## ADDENDUM NO. 1

WASHINGTON STATE PARKS AND RECREATION COMMISSION  
POTHOLES STATE PARK  
SEWER LIFT STATION REPLACEMENT  
EW-C6701

DATE: March 31, 2025

### INDEX

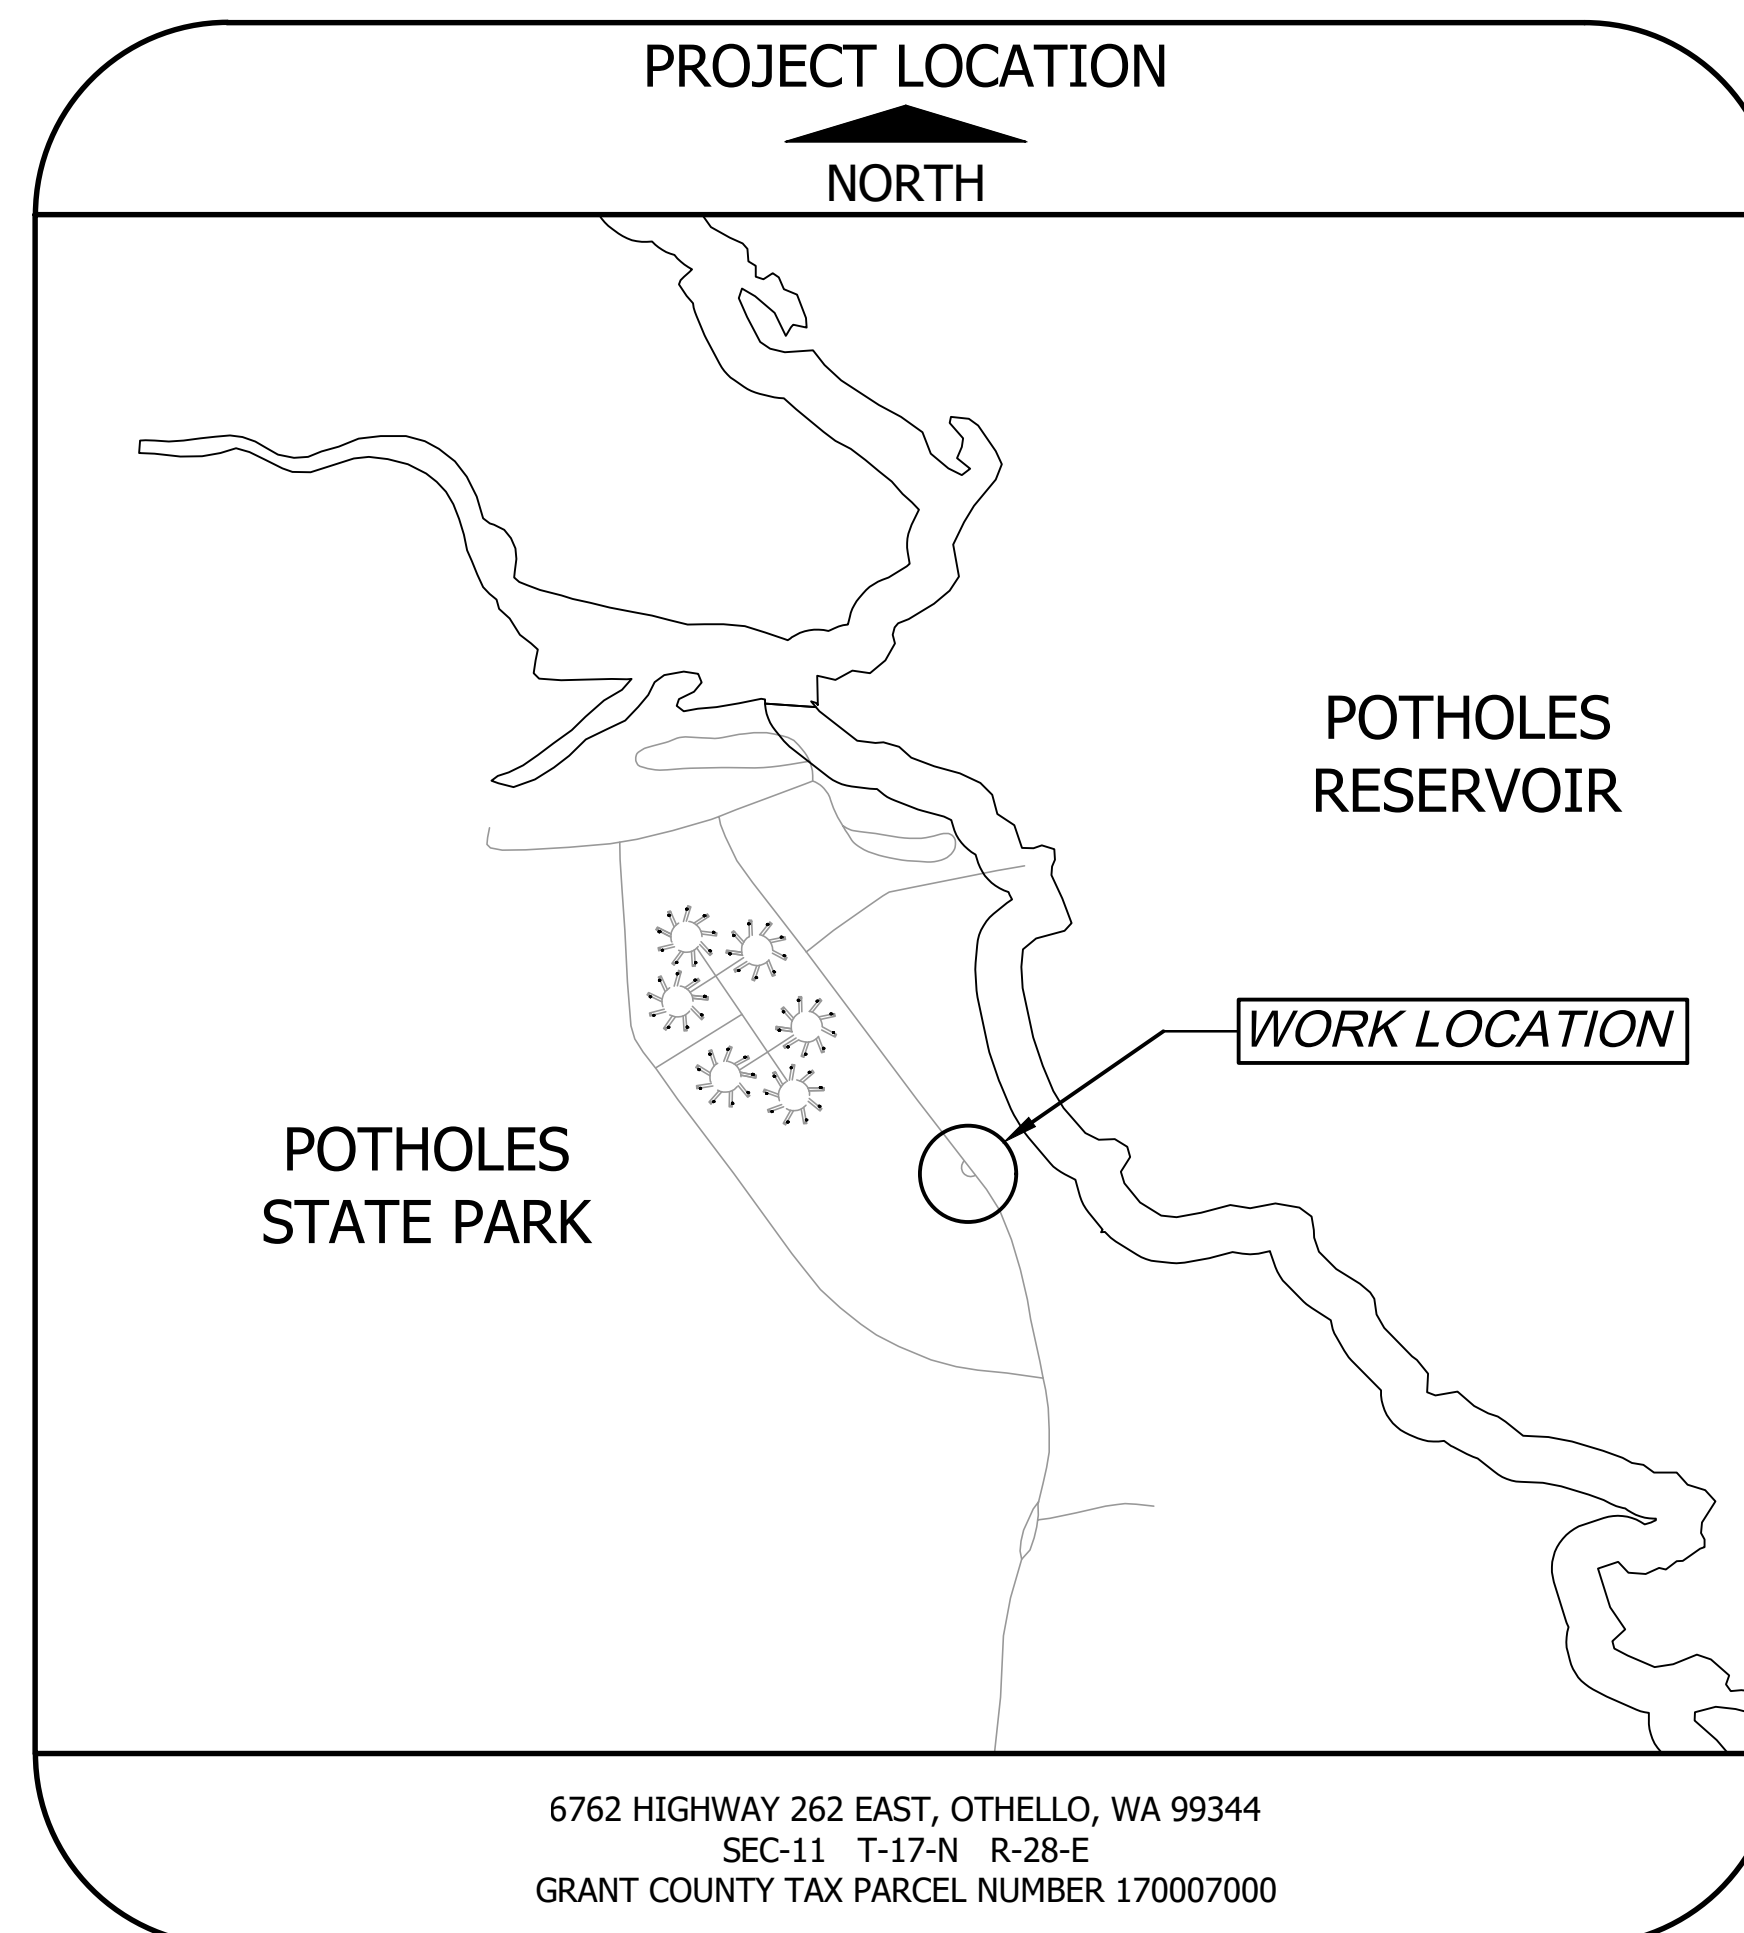
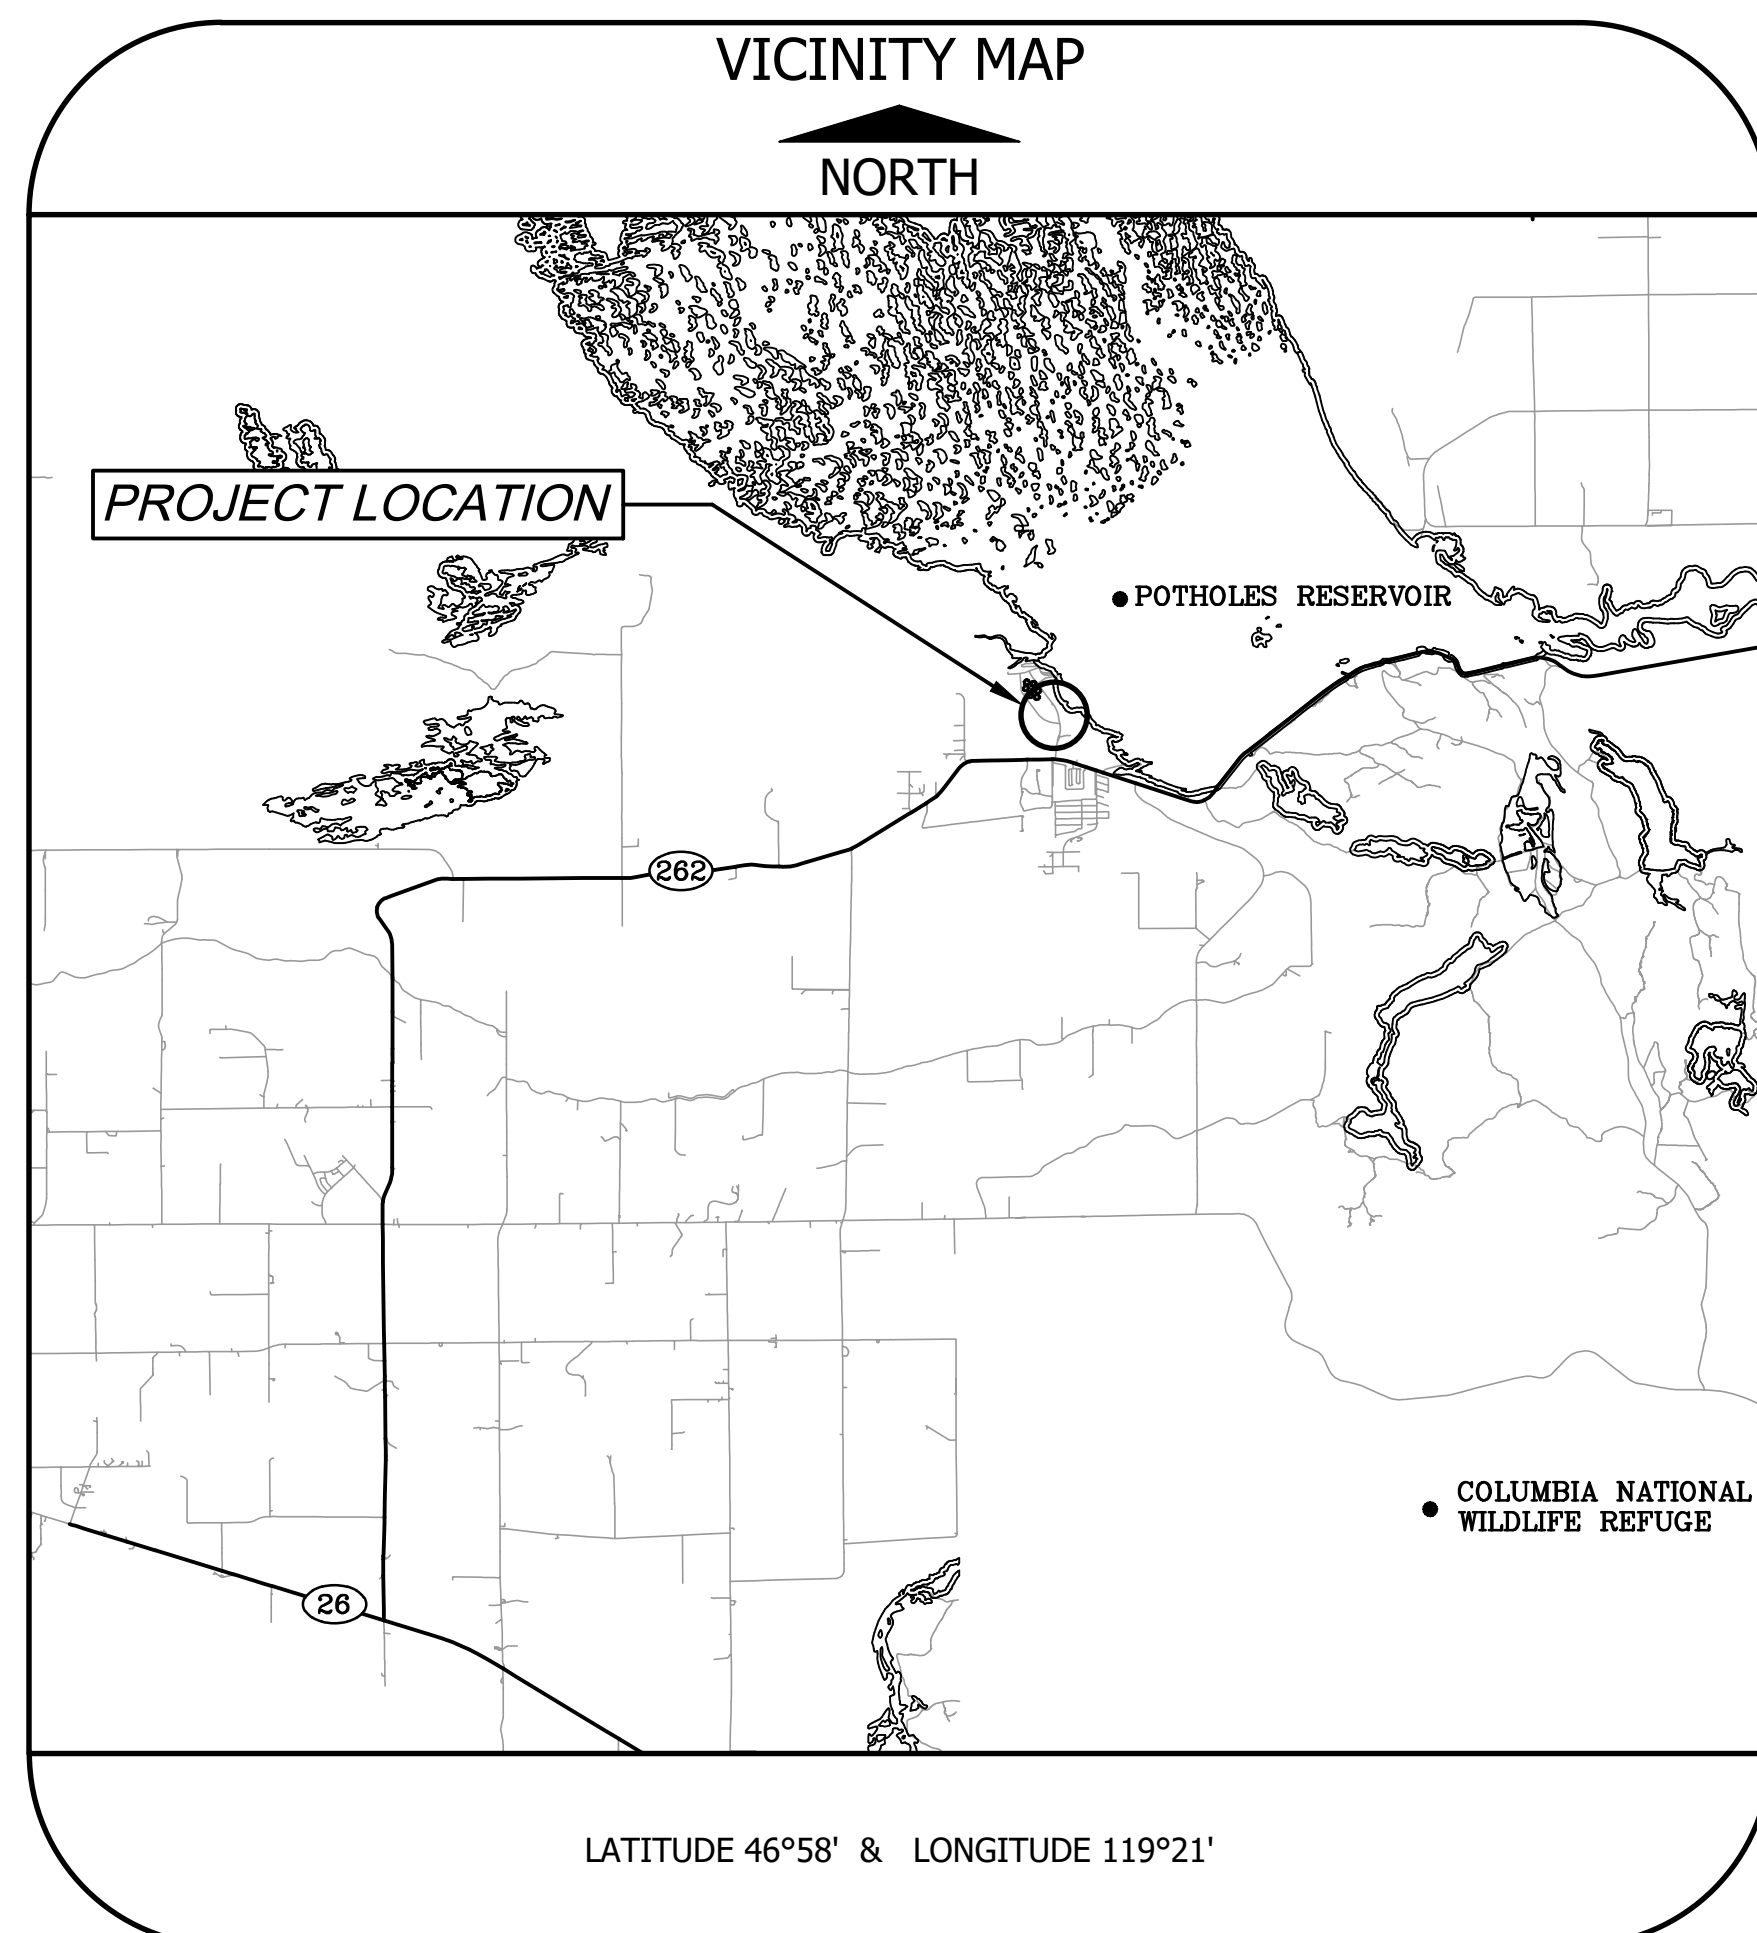
- The posted drawing set has been revised.
- On the original **Cover Sheet**, an error was discovered in the Index. The revised drawing set has the cover page with the correct index.

SHEET	DESCRIPTION
1	COVER SHEET
2	GENERAL INFORMATION
3	EXISTING SITE PLAN
4	LIFT STATION SITE PLAN
5	EXISTING MECHANICAL AND DEMOLITION PLAN
6	MECHANICAL PLAN 1
7	MECHANICAL PLAN 2
8	MECHANICAL DETAILS
9	STRUCTURAL PLAN 1
10	STRUCTURAL ELEVATIONS AND PLAN
11	LIFT STATION DETAILS 1
12	LIFT STATION DETAILS 2
13	FORCEMAIN CONNECTION DETAIL
14	ELECTRICAL LEGEND
15	ONE-LINE DIAGRAM
16	ELECTRICAL SITE PLAN
17	CONTROL LOGIC DIAGRAM
18	ENCLOSURE DETAILS
19	ELECTRICAL DETAILS
20	ELECTRICAL SCHEDULES
